## Product Change Notification

| <b>Pulse PCN No.</b>                                   | PCN-100000693   |  |
| /  | JD4-0012NL  | 3/5/2025   |

| <b>Summary of Changes between the new and old part</b> | <b>Present</b>  | <b>New</b>   |

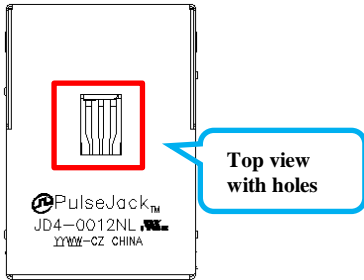
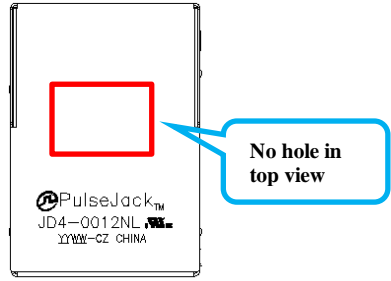
| <b>Description of Change</b>                           | The top view of the drawing has holes changed to no holes, No impact to product form, fit and function.   |  |
